# 1. Executive Summary

This report is an assessment of the application to modify the approved alterations and additions, including altering and extending the approved rear projecting single-storey living room structure at 95 Grove Street, Birchgrove.

The proposal includes modifications to the alterations and additions to the dwelling approved under D/2019/252. The modification includes altering and extending the approved rear projecting single-storey living room structure of the additions 1.494m rearward and 1.3m toward the south-eastern side boundary. The roof form of this structure is also proposed to be altered so as not to create additional shadow impact to the rear of 93 Grove Street.

ABOVE: The red circled area identifies the side window serving the living room in 93 Grove Street. The purple shaded area represents shadow falling the rear side awning adjoining the kitchen. No new shadows are cast to the dwelling from works the subject of the Modification Application.

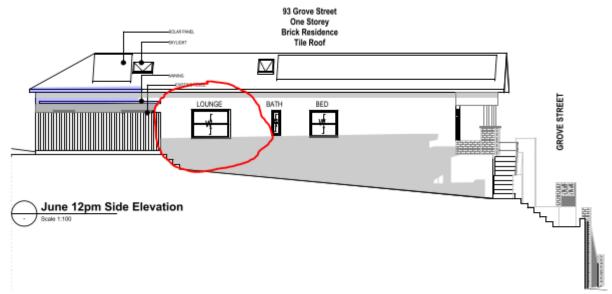
The proposed modifications to the rear projecting single-storey living room structure of the approved development will not result in additional shadow impacts to the side living room window of 93 Grove Street. Solar access to this window satisfies the provisions of control C12 to Part C3.9 LDCP2013.

As the footprint of the rear single storey loungeroom is proposed to be increased, the applicant was requested to amend the modification drawings to reduce the overall height of this rear element by 300mm so as to reduce apparent bulk of the enlarged room and to ensure that no significant additional shadows impact 93 Grove Street. The plans the subject of this report reflect that reduction.

The shadow diagrams submitted with the amended plans, the subject of this report, reflect both the reduction in shadow impact as a result of redesign to satisfy condition 7, and also, the further requested reduction in overall height of the loungeroom roof by 300mm. These diagrams confirm that the proposed modifications to the approved additions would not result in a breach of the solar access controls in respect to 93 Grove Street.

In this regard the submitted shadow diagrams demonstrate that the proposed modifications do not impact the side living room window of No.93 Grove Street and satisfy control C12. Further, the proposed modification to the rear ground floor room satisfies control C18. In this regard, the rear yard private open space of 93 Grove Street would receive 50% solar access for 2.5 hours between 11am and 2pm at the winter solstice.
